ADDENDUM NO. 1 – November 14, 2016

BID NO. IFB 16-130

**CITY OF LAKE WORTH
WATER TREATMENT PLANT UPGRADES AND IMPROVMENTS**

1 WALKWAY ENCLOSURE SECTION

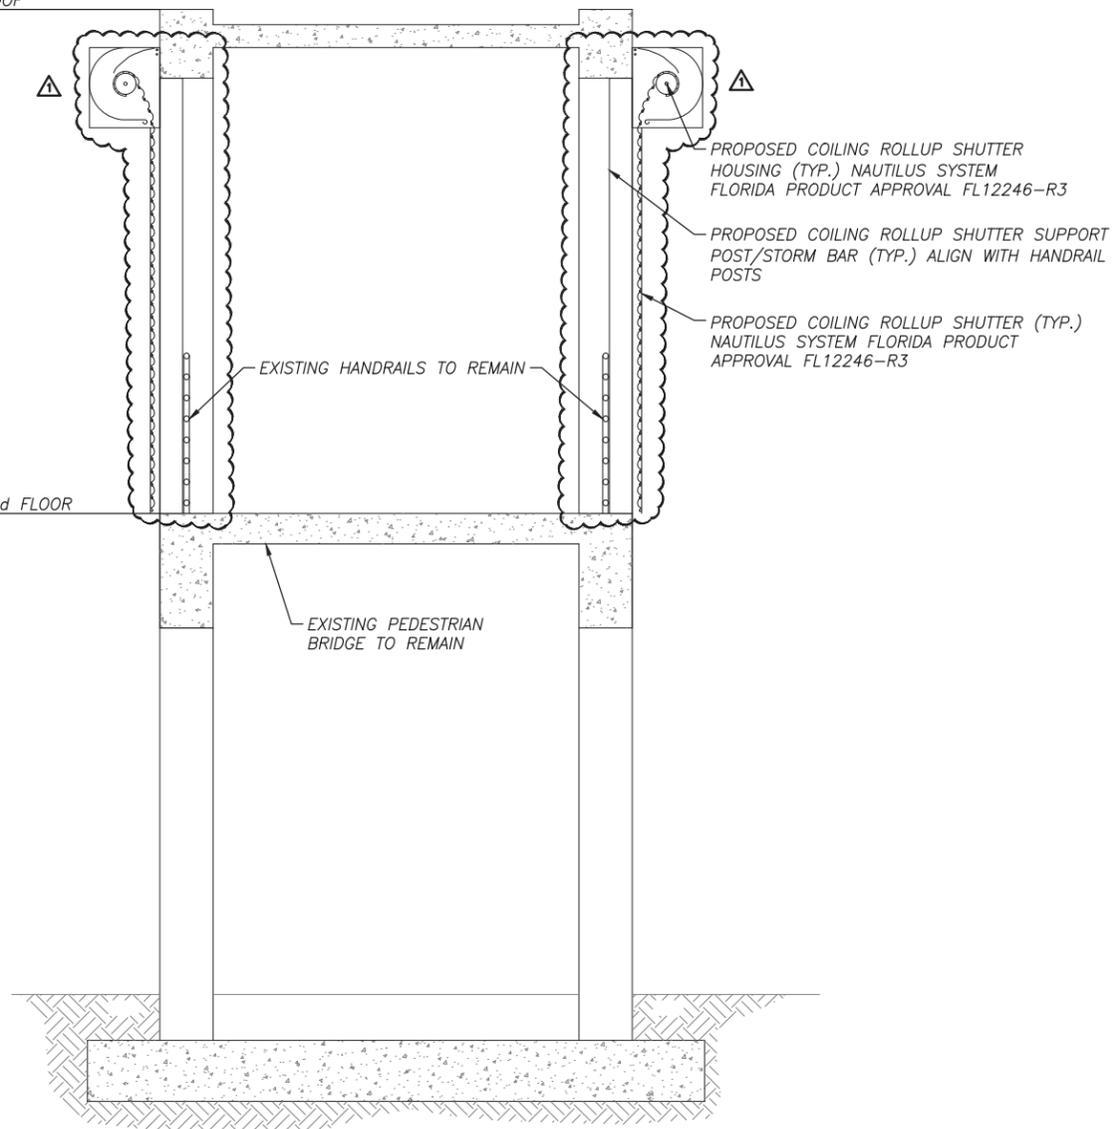
- A. **REPLACE** Volume No. 3 - Sheet No’s S10.0, S10.1 and S10.2 of the project drawings with the revised version included in **ATTACHMENT D**. The drawings were revised to specify the installation of the coiling rollup shutter units on the exterior of the walkway to avoid conflicts with existing electrical equipment, fire alarm cabinets, etc.

NO.	REVISION	DATE	BY
1	CHANGE INT. TO EXT. MOUNT	11-08-2016	D.A.M.

ROLLING SHUTTER SYSTEM

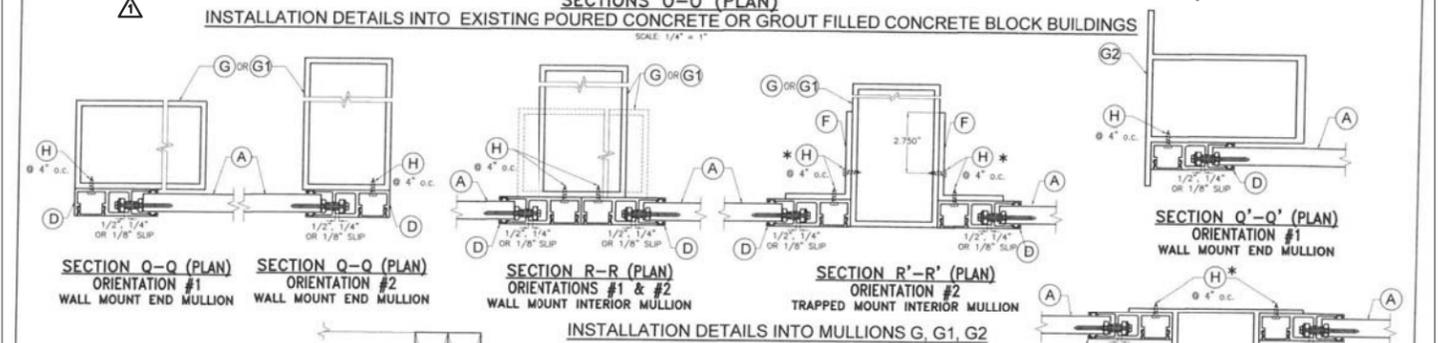
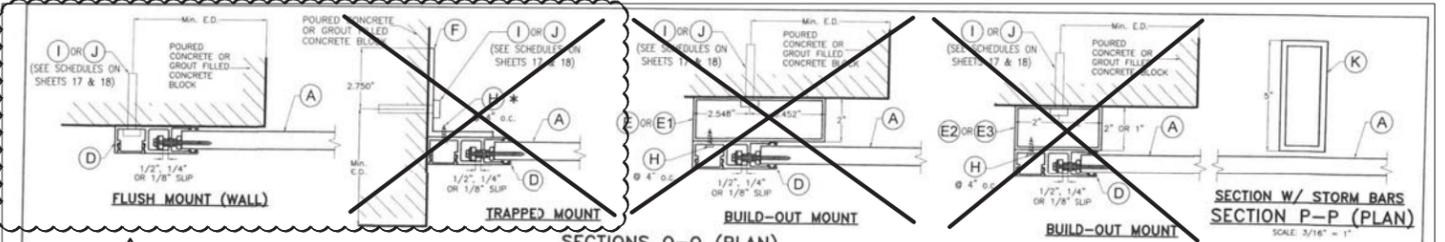
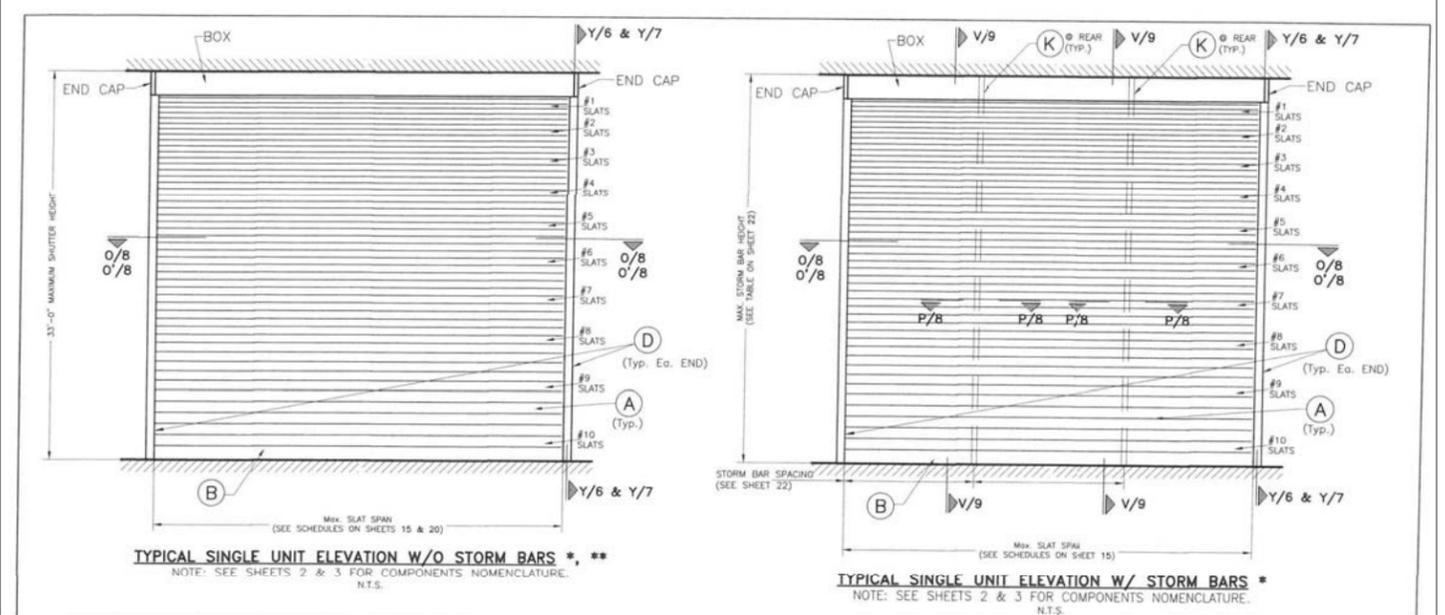
NO.	REVISION	DATE	BY
1	CHANGE INT. TO EXT. MOUNT	11-08-2016	D.A.M.

1. THE ROLLING SHUTTER SYSTEM SHALL BE NAUTILUS AS MANUFACTURED BY EXPERT SHUTTER SERVICES FLORIDA PRODUCT APPROVAL FL12246-R3
2. THE SYSTEM SHALL USE **FLUSH** MOUNTED INSTALLATION AS DEPICTED IN THE FL12246-R3 PRODUCT APPROVAL.
3. CONTRACTOR SHALL BE RESPONSIBLE FOR THE ENGINEERING DESIGN OF THE ANGLE ATTACHMENT TO THE EXISTING COLUMN. THE DESIGN SHALL AVOID EXISTING LIGHTS, FIRE ALARM, PANELS AND SURFACE MOUNTED CONDUIT. DESIGN CALCULATIONS SHALL BE PROVIDED BY A FLORIDA LICENSED PROFESSIONAL ENGINEER.
4. ALL FASTENERS SHALL BE STAINLESS STEEL 316.
5. SERVICE DESIGN PRESSURE SHALL BE +/- 75 PSF.
6. ALL ALUMINUM IN CONTACT WITH CONCRETE SHALL BE COATED WITH A BITUMINOUS EPOXY.

NOTE: THE ABOVE SHEETS ARE EXCERPTS FROM THE FLORIDA PRODUCT APPROVAL FL12246-R3.
